SUBJECT: ADDENDUM # 1

PROJECT TITLE: MEP Renovations to Earl Hall, SCSU

PROJECT NO.: BI-RS-248

BID OPENING	1:00 P.M.	DECEMBER 22, 2009
ADDENDUM NUMBER ONE	DATE OF ADDENDUM	DECEMBER 14, 2009

REVISION TO DRAWING NO:
M-200

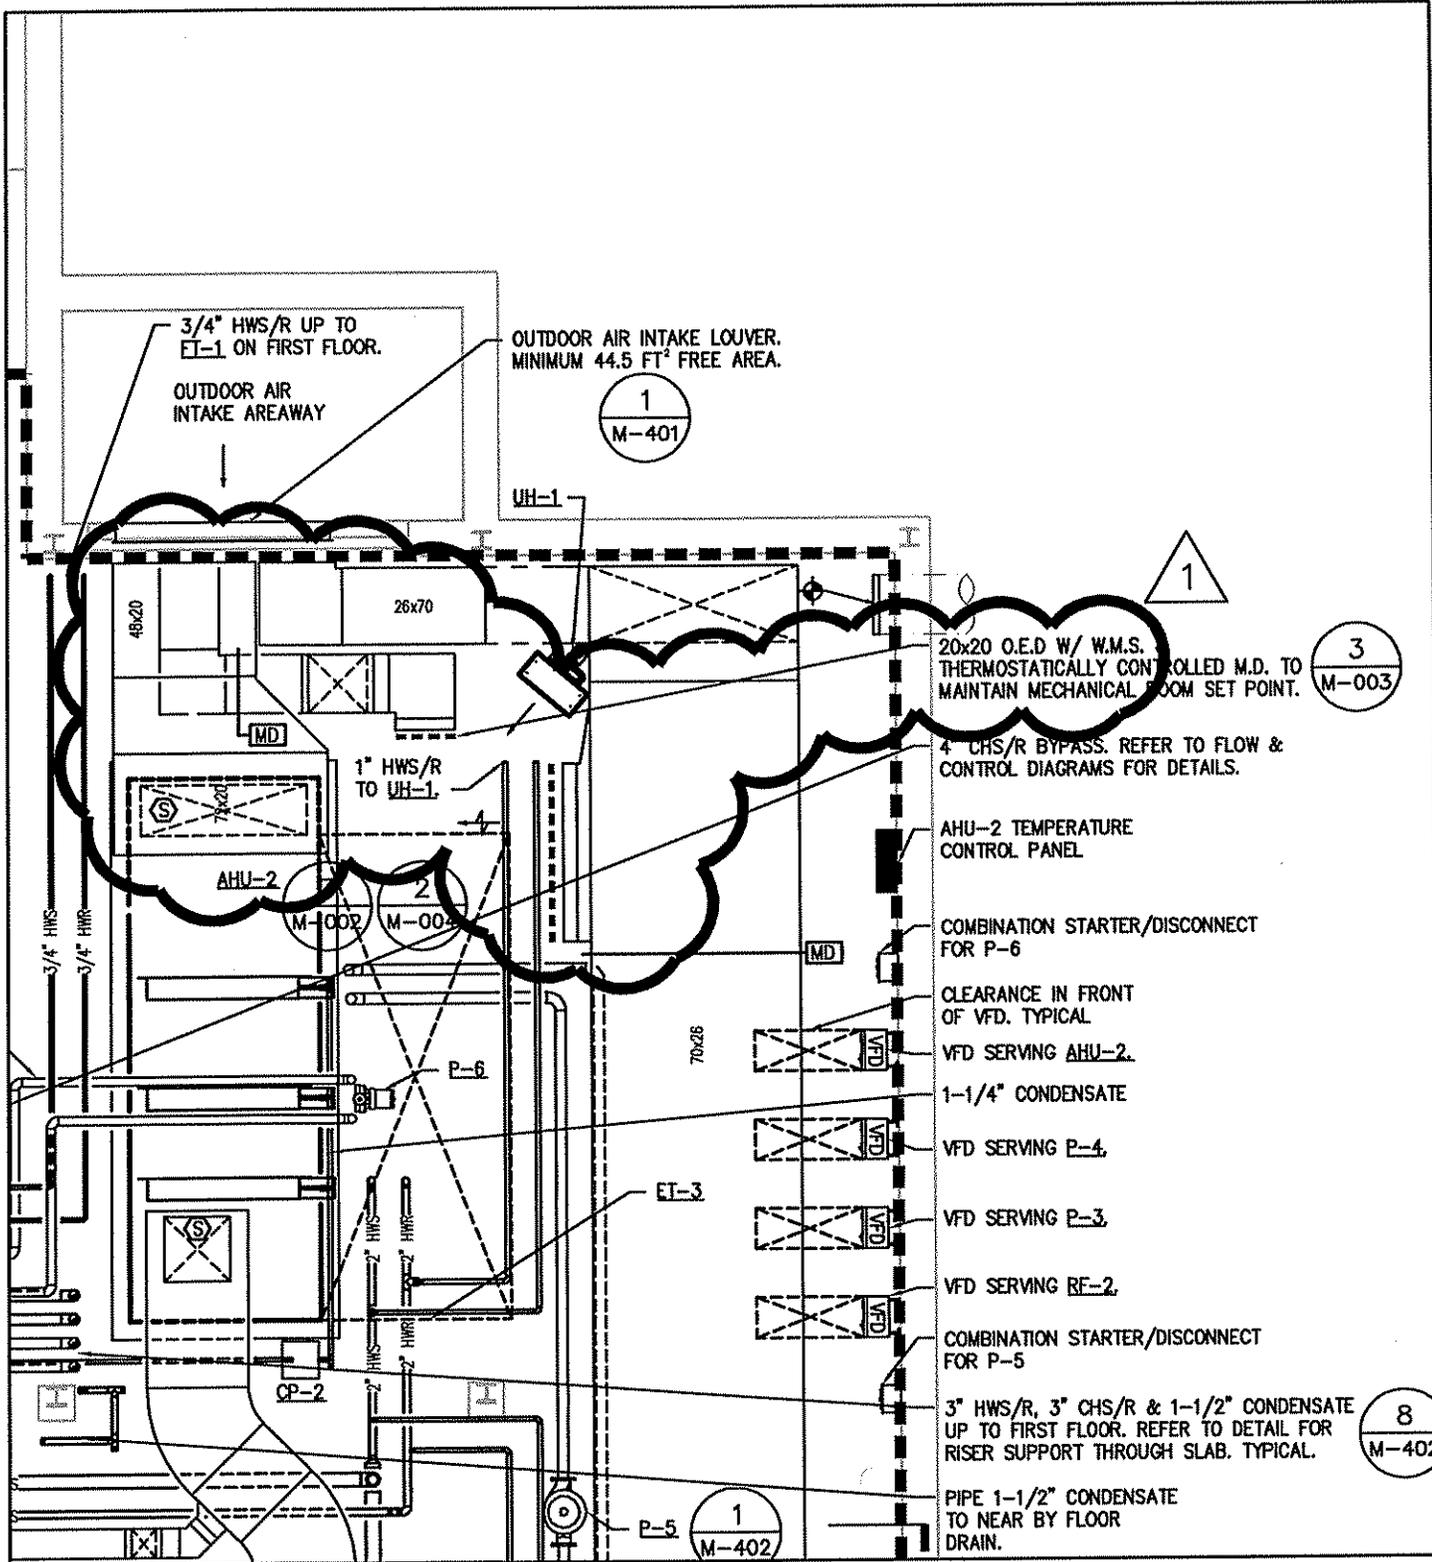
DRAWING: M-200

Revised the outdoor air duct connection to the outdoor air intake louver. Refer to mechanical sketch SK-M1.

REVISION TO DRAWING NO:
M-201

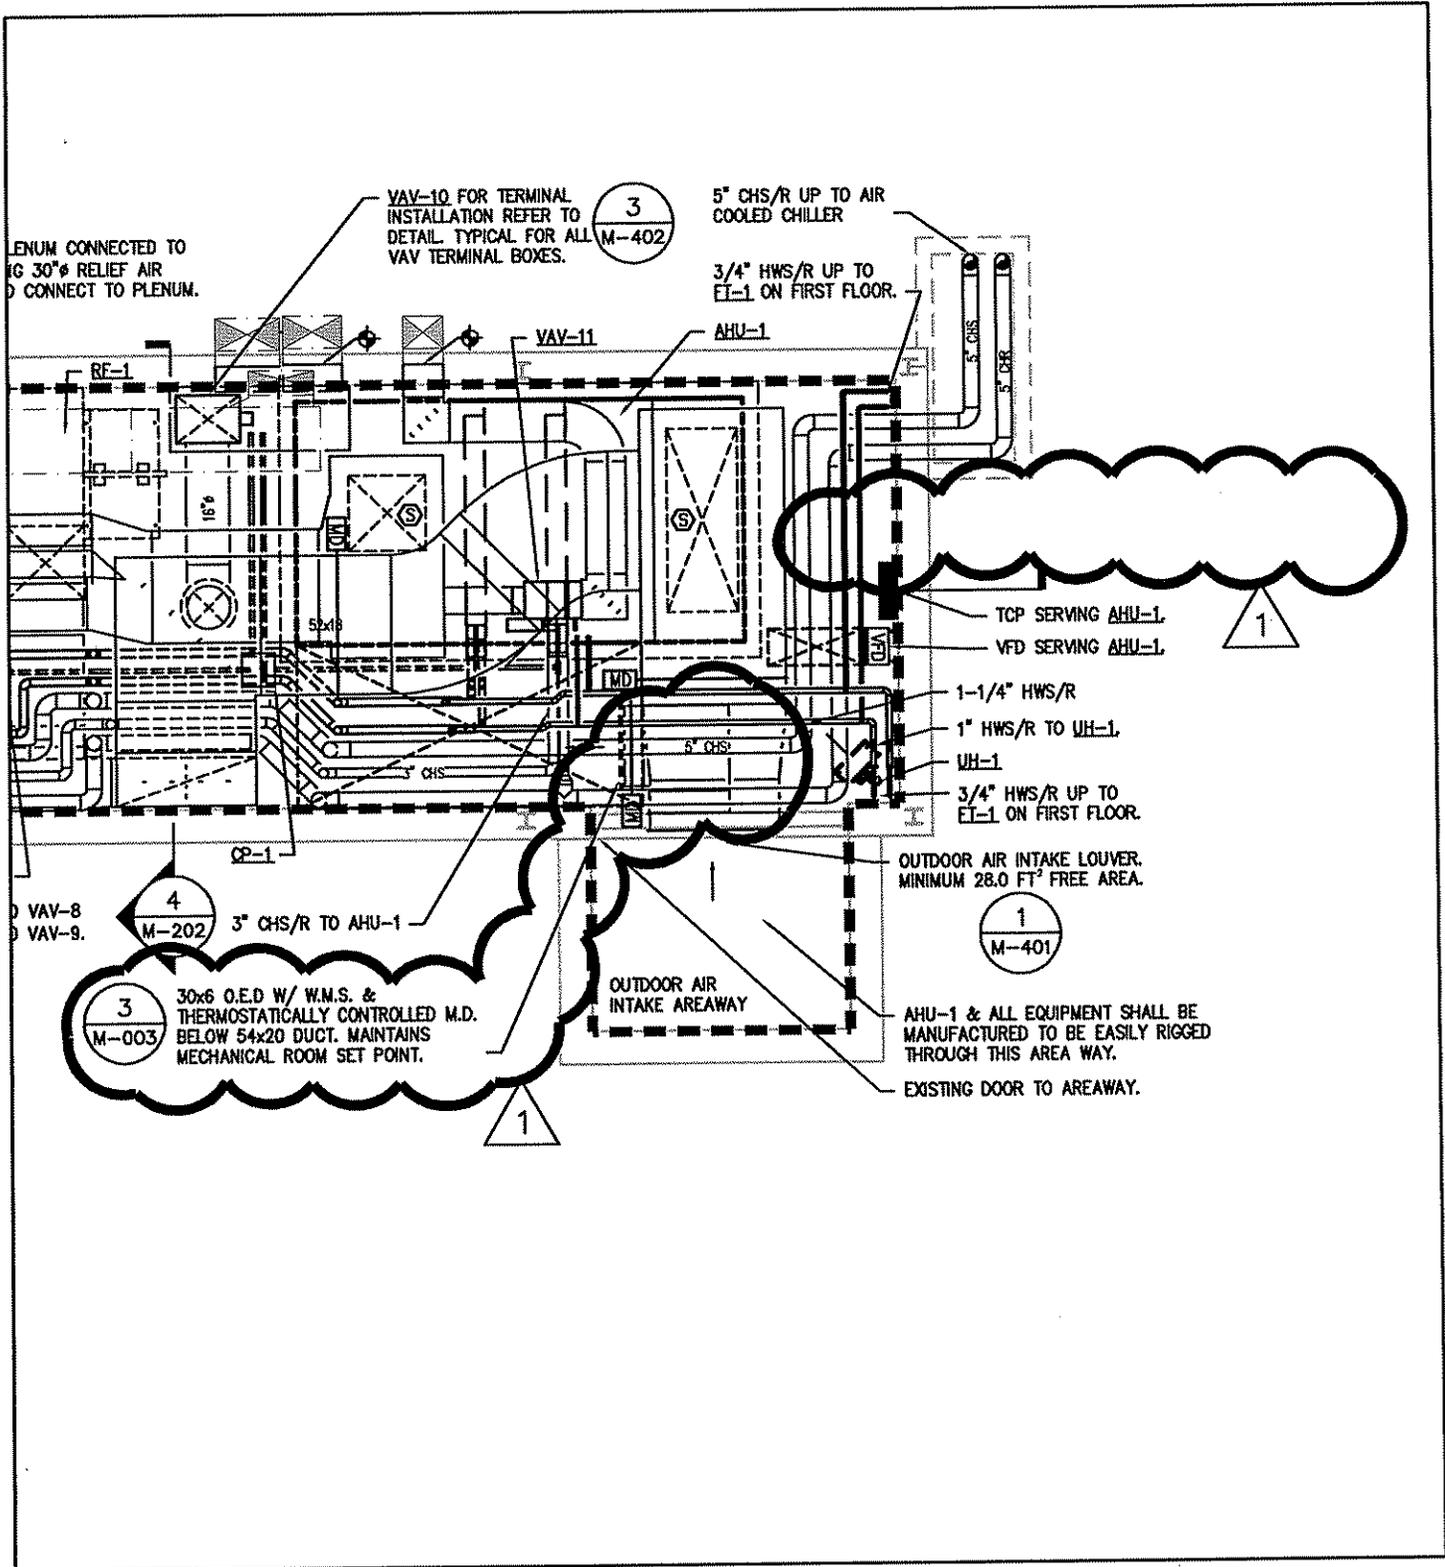
Item 10

DRAWING: M-201

Revised the outdoor air duct connection to the outdoor air intake louver. Refer to mechanical sketch SK-M2.

DRAWING NO:
SKP-1
 DATE: 12-11-09
 SCALE: NONE

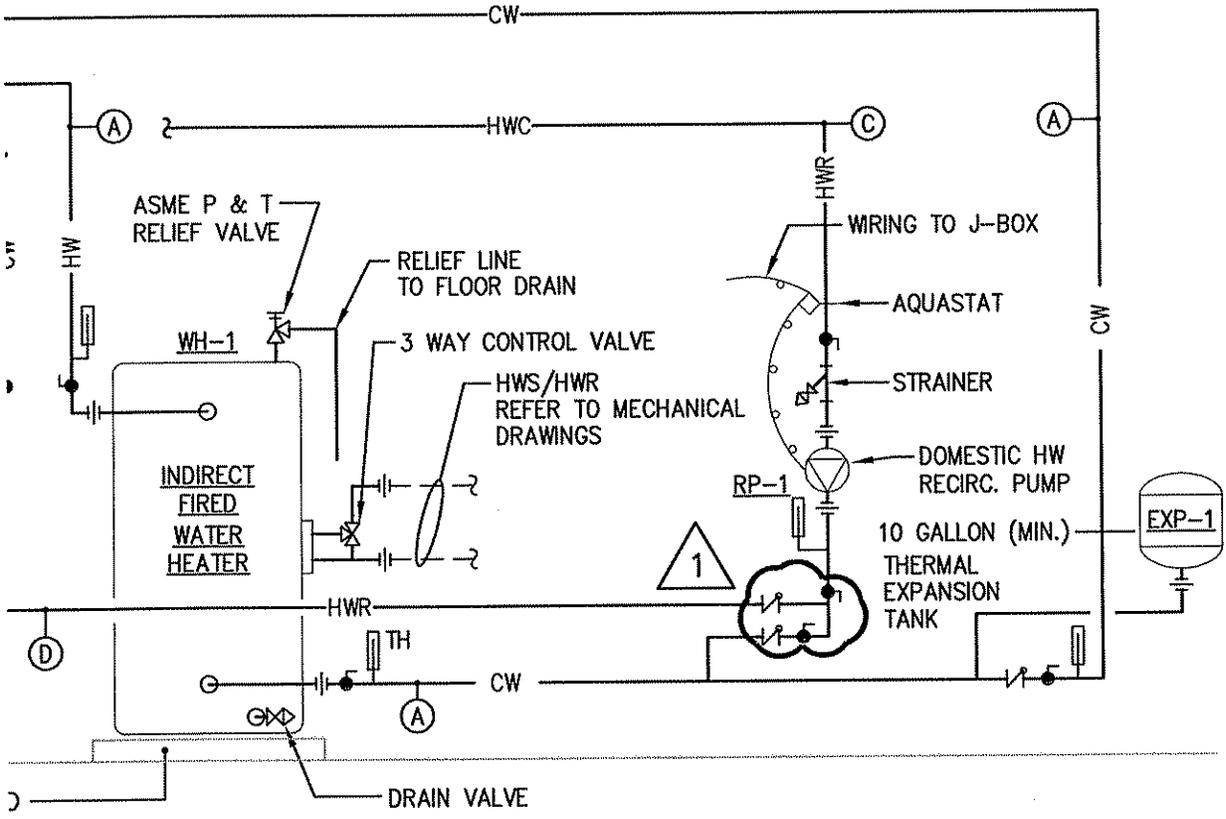
Item 8

DRAWING: P-201 Detail 2: Water Heater Piping Diagram

Revised the detail. Refer to SKP-1.

SK-A1

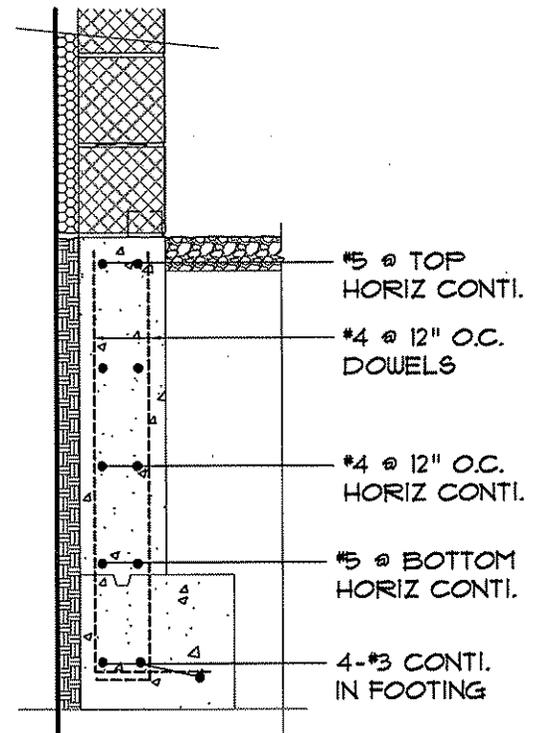
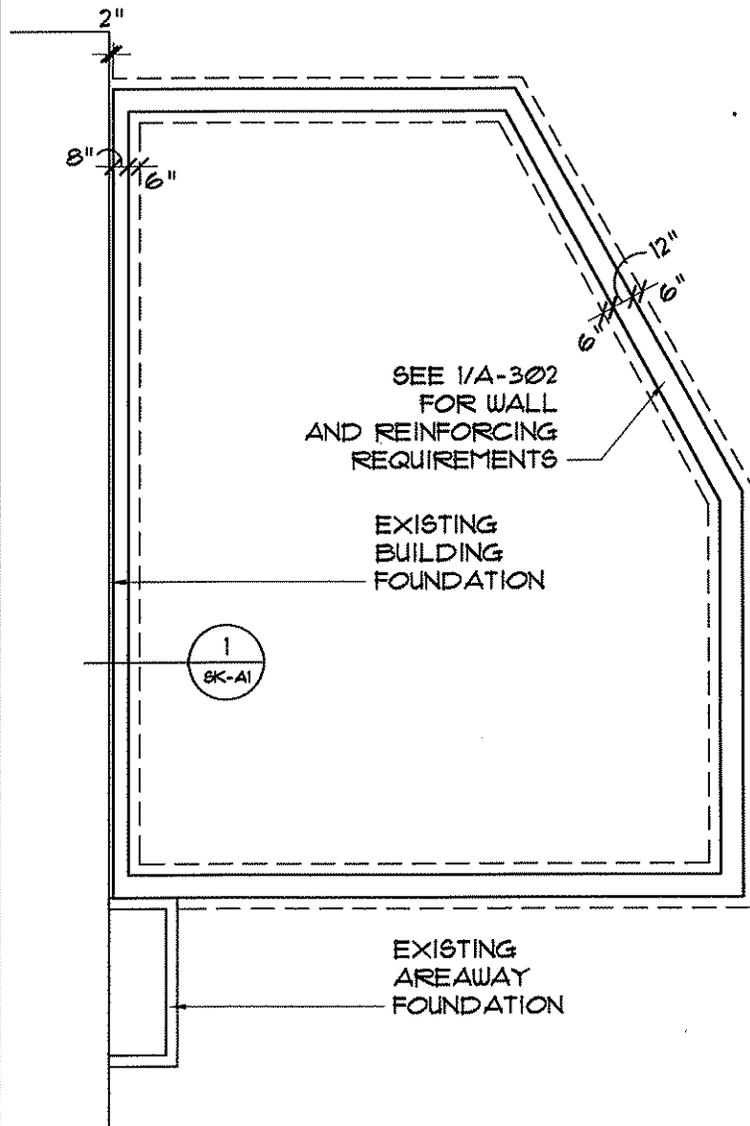
Item 5-RFI question:

Can you please confirm the foundation requirements at the chiller enclosure as illustrated on 7/a-302 along the existing building. The section only addresses the CMU wall, not the concrete. It doesn't seem likely that a foundation already exists in this area.

ANSWER:

Please see attached SK-A1 for foundation requirements for the chiller enclosure.

SKF-1

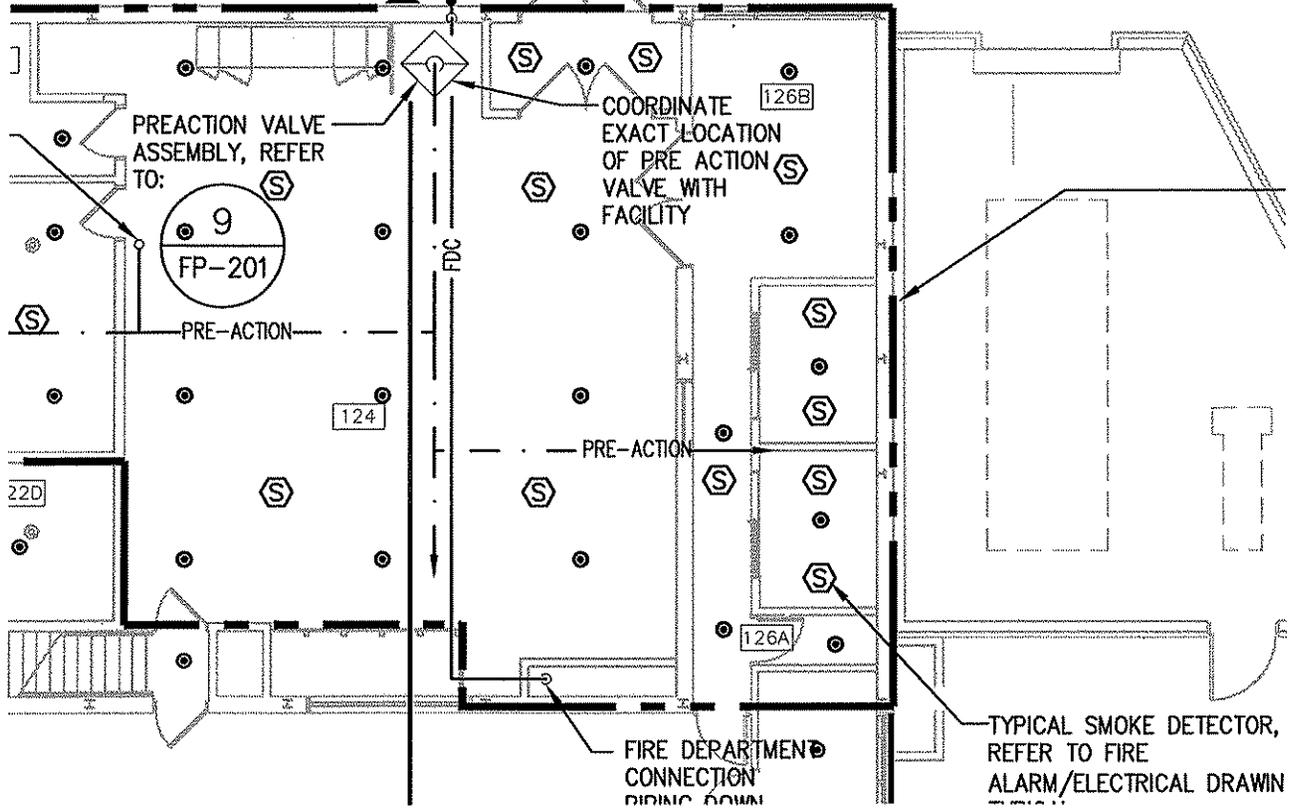
Item 23- RFI question:

Request: The above referenced drawings show conflicting information for the proposed Fire Department Connection. Sheet 100 specifies 6-inch piping and FDC whereas FP-101 calls for a 4-inch FDC and piping. Please Clarify.

ANSWER:

The fire department connection shall be 6", the drawings shall be revised accordingly. Refer to fire protection sketch SKF-1.
